## RV dwellers can park on private property in residential areas under new ordinance

**From:** [Tanner, Rachael](#)  
**To:** [David Rogosa](#)  
**Cc:** [Planning Commission](#)  
**Subject:** RE: 985 Channing. Follow-up commentary and materials from Oct 13 deliberations, D Rogosa  
**Date:** Wednesday, November 24, 2021 1:03:59 PM  
**Attachments:** [DRogosaPTC11-10.pdf](#)  
[image001.png](#)  
[image002.png](#)  
[image004.png](#)  
[image005.png](#)  
[image006.png](#)  
[image007.png](#)

DUNLAP RESIDENCE

985 CHANNING AVENUE  
 PALO ALTO, CA 94301

**A6.2**

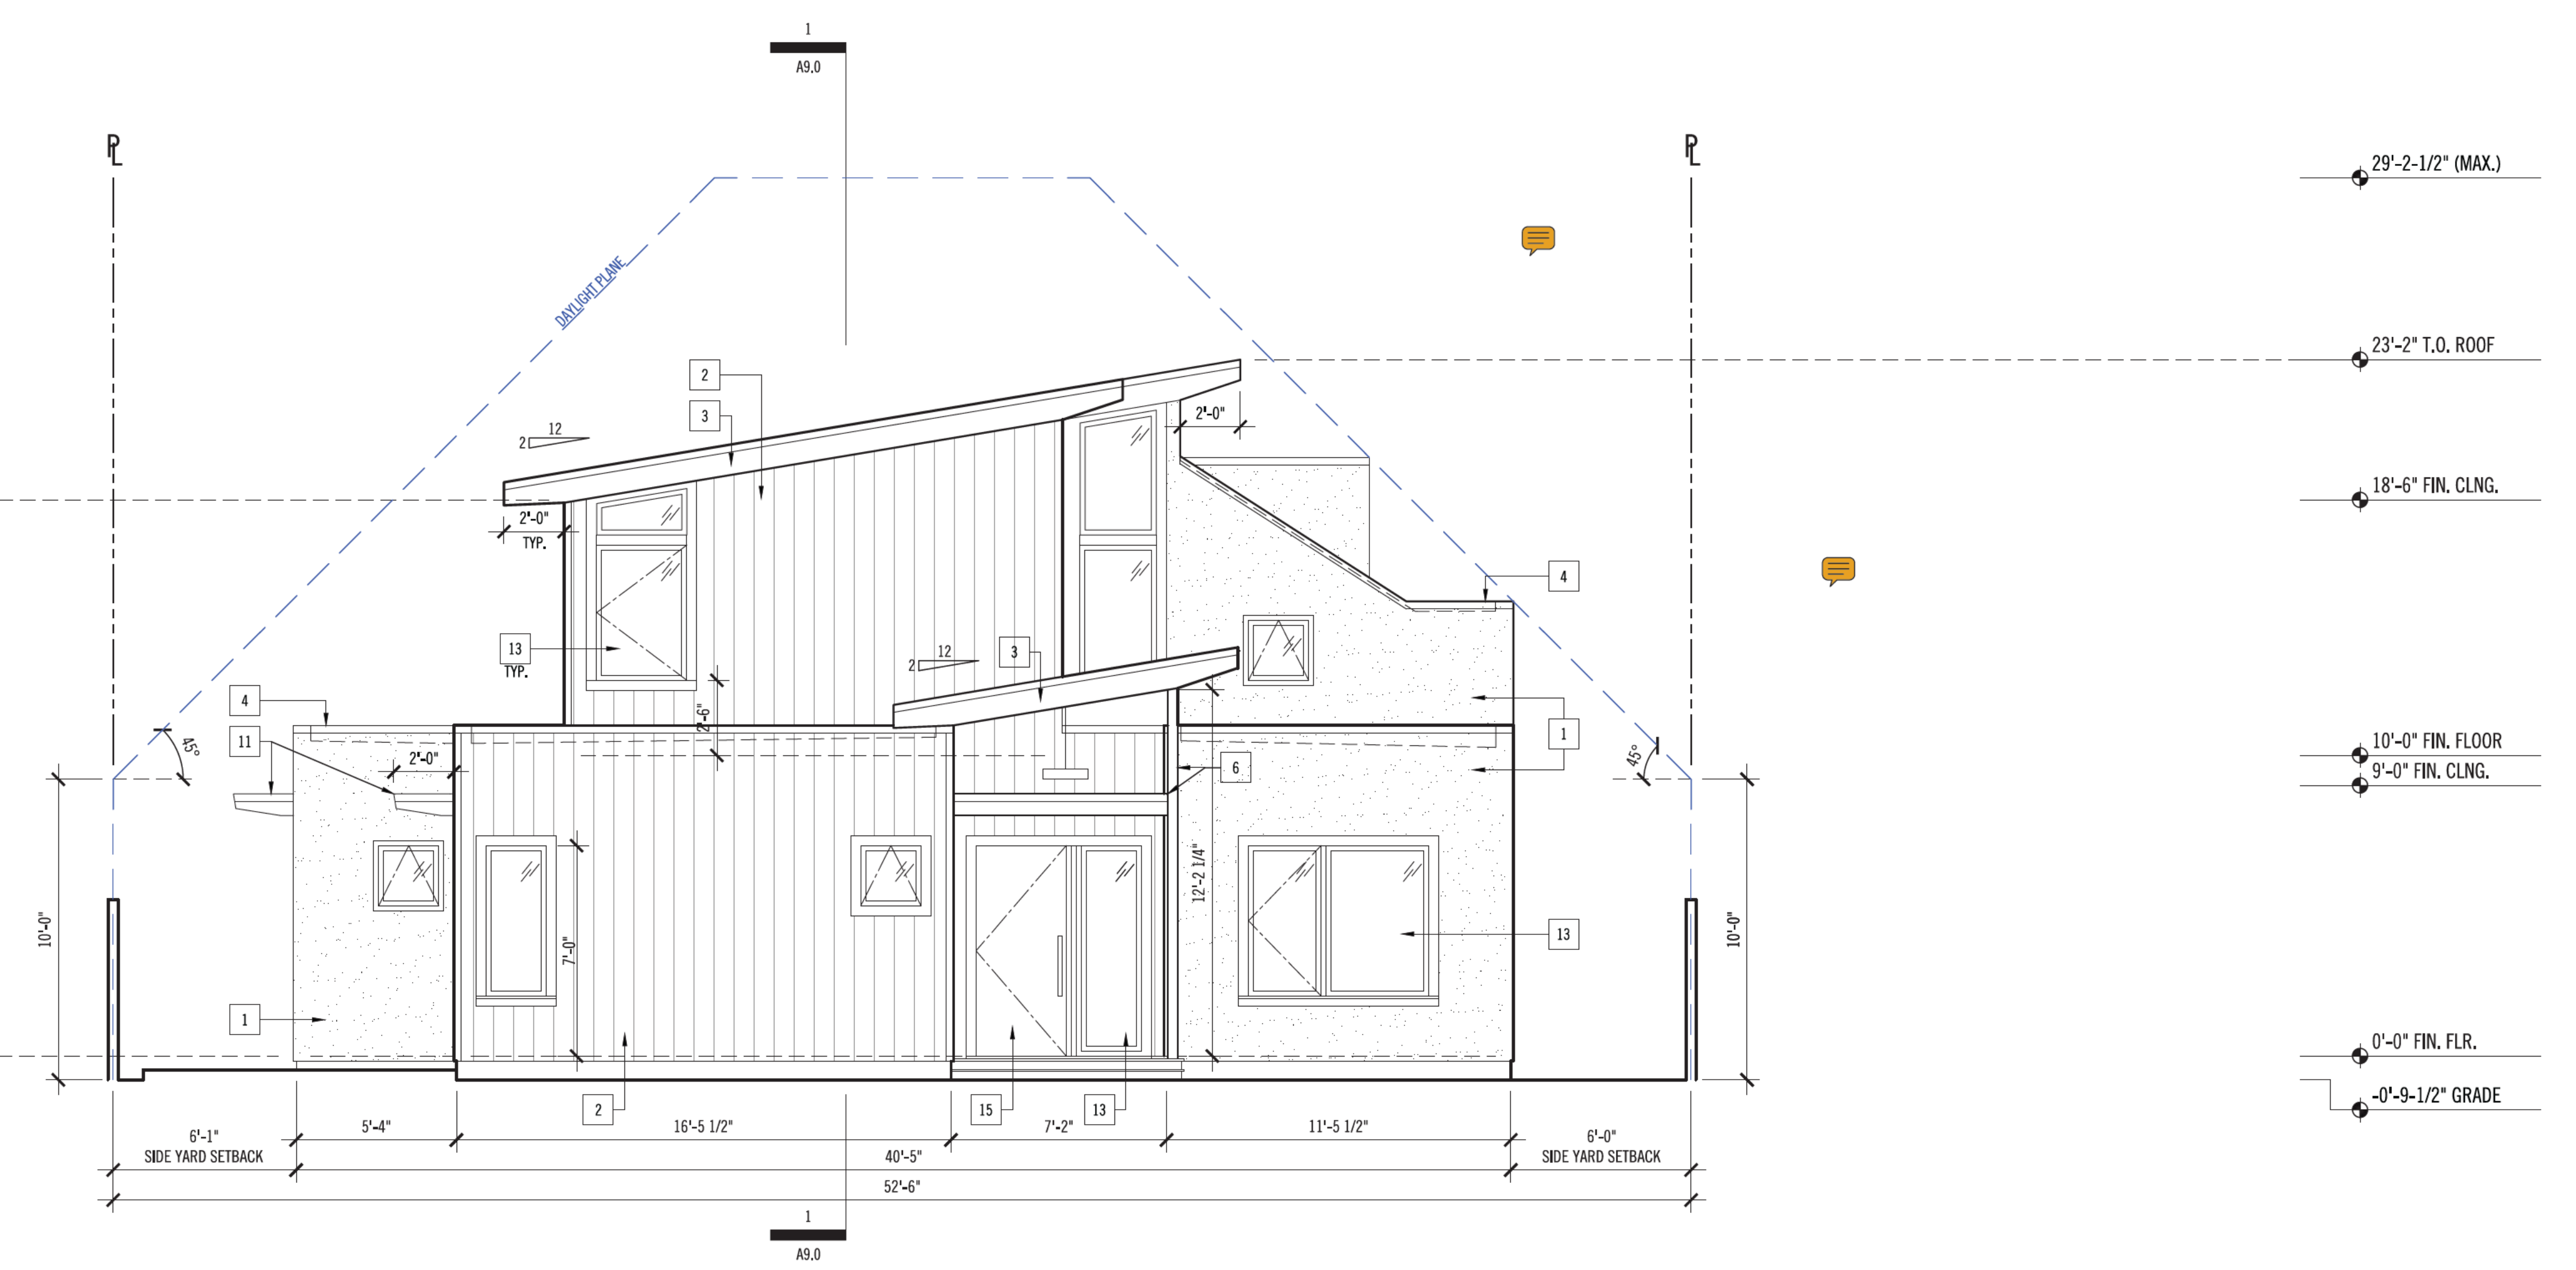
A6.2	Callout	Arnold Mammarella : Planning IR	IR-5: To meet guideline five, revise the second-floor plan's window locations to match the revised left side elevation as required to meet privacy requirements at these side facing windows.

2 PROPOSED ROOF PLAN  
1/4"=1'-0"

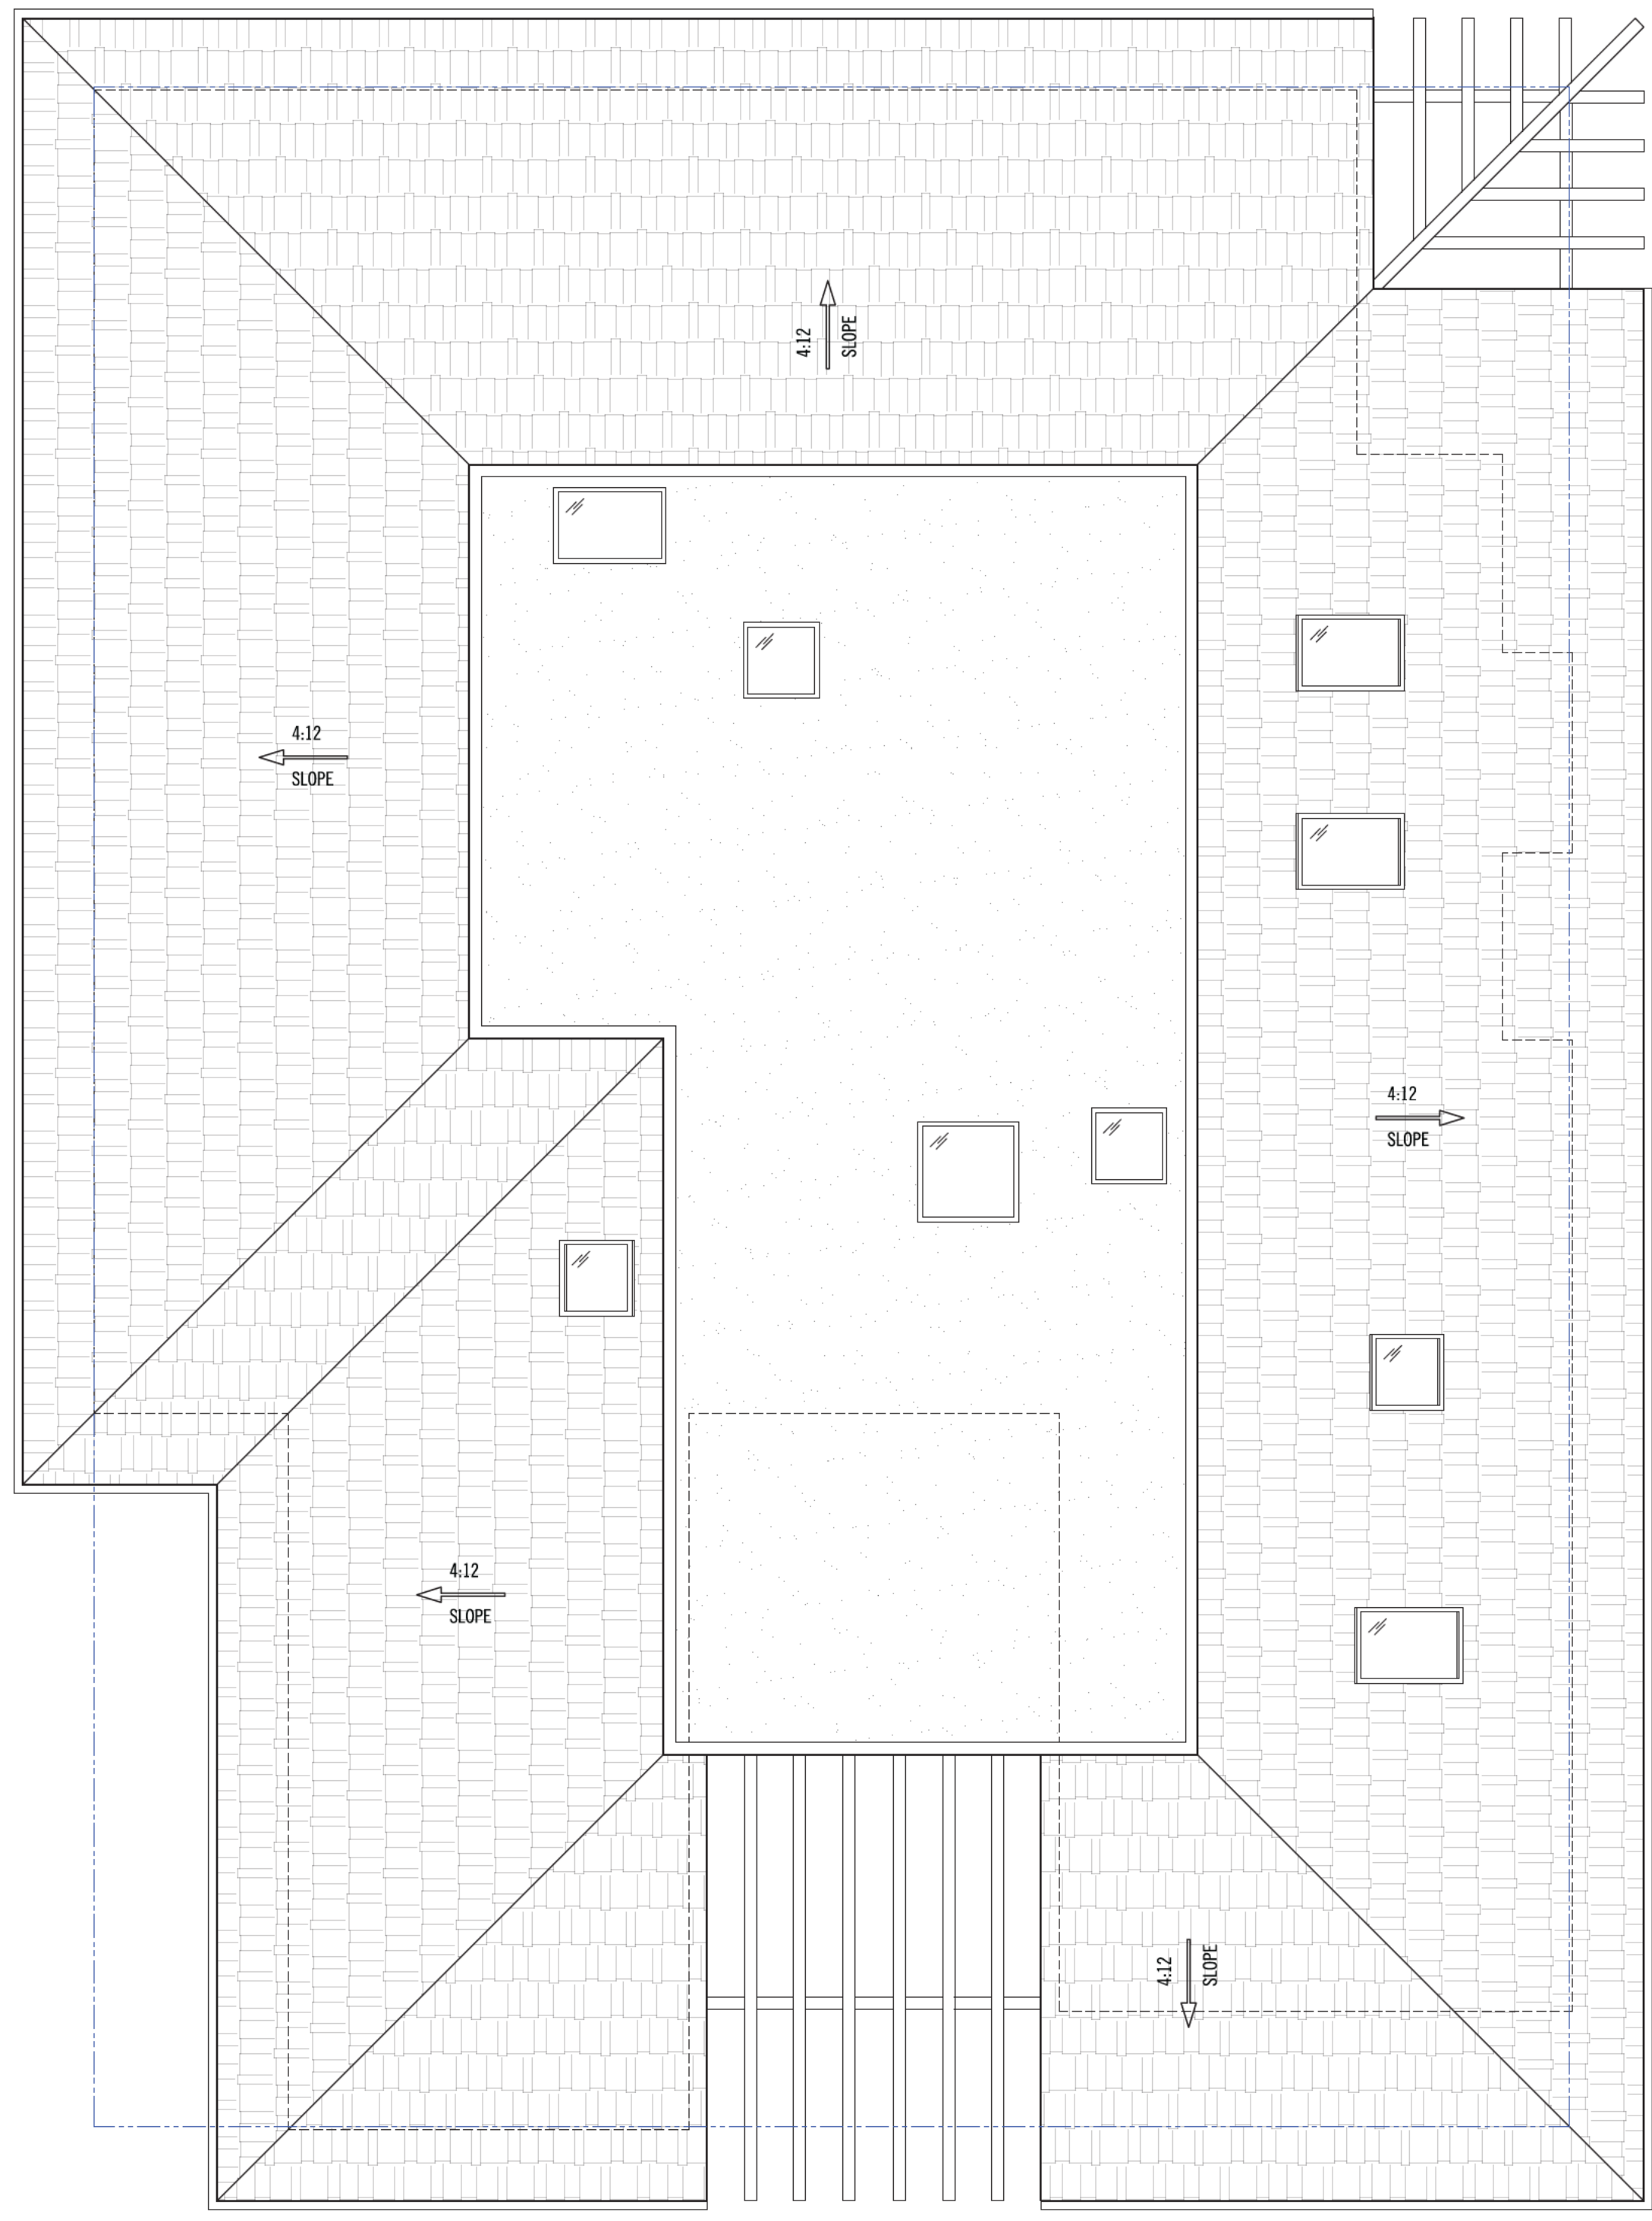
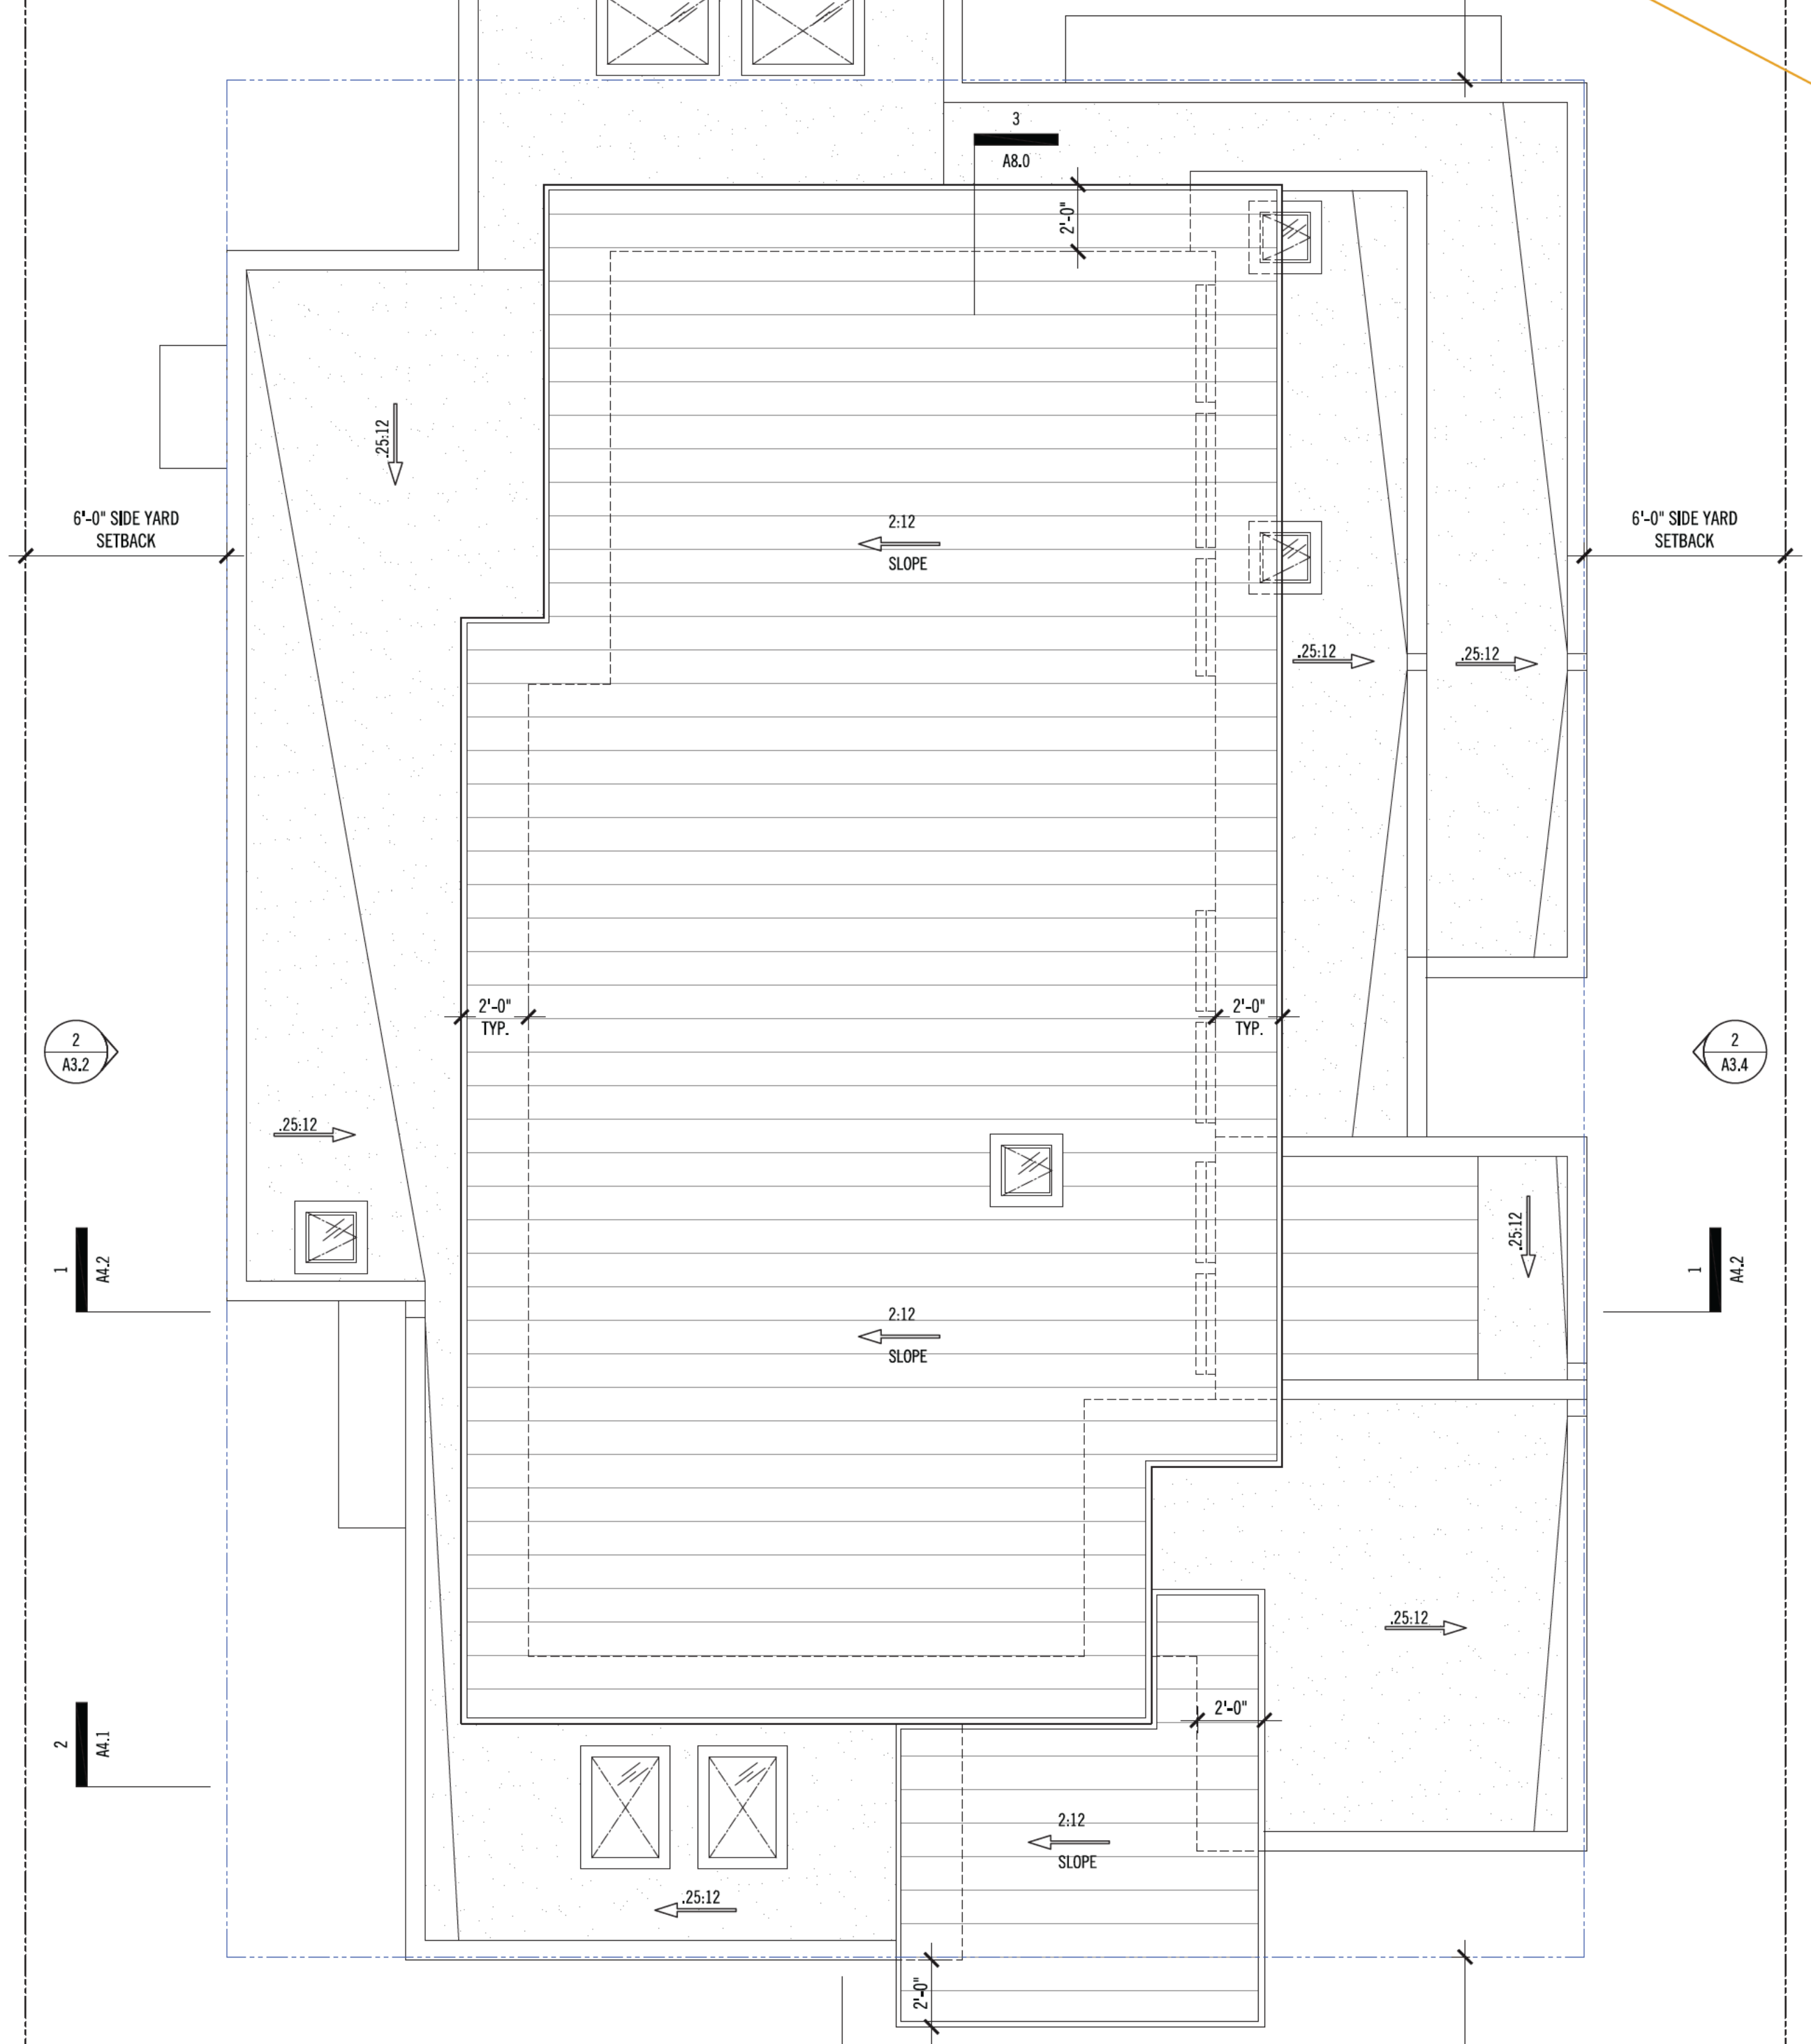
Clarify outline of drawing to identify top of roof and bottom of roof slope.
